| <b>Subject:</b><br><br><b>RATTLING NOISE FROM SECOND SEAT UNDER VARIOUS VEHICLE SPEEDS AND ROAD CONDITIONS</b> | <b>Bulletin No.:</b> 09-017/26  |
|  | <b>Last Issued :</b> 05/20/2026 |

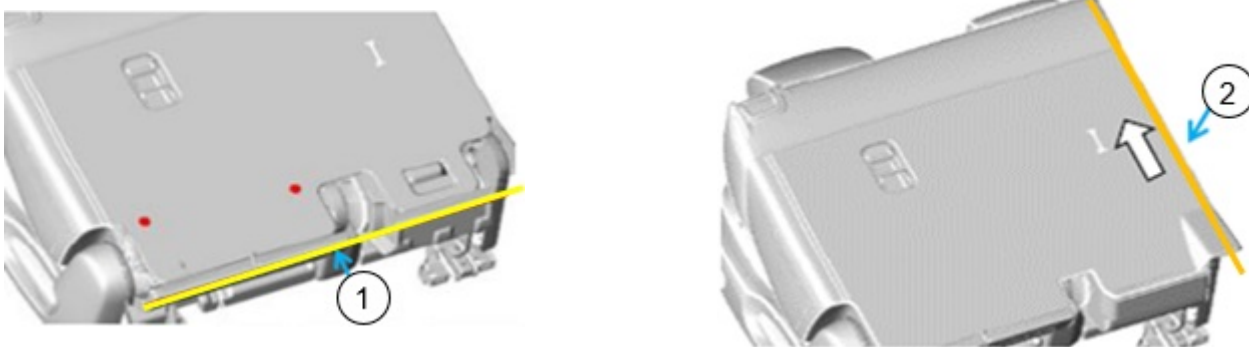
Some customers may complain that a rattling noise is heard from the second seat while driving under various vehicle speeds and road conditions. This is caused by the hinge cover of the second seat becoming deformed, resulting in looseness and a rattling noise.

To eliminate this concern, the structure of the second seat hinge cover was revised to increase strength and prevent deformation.
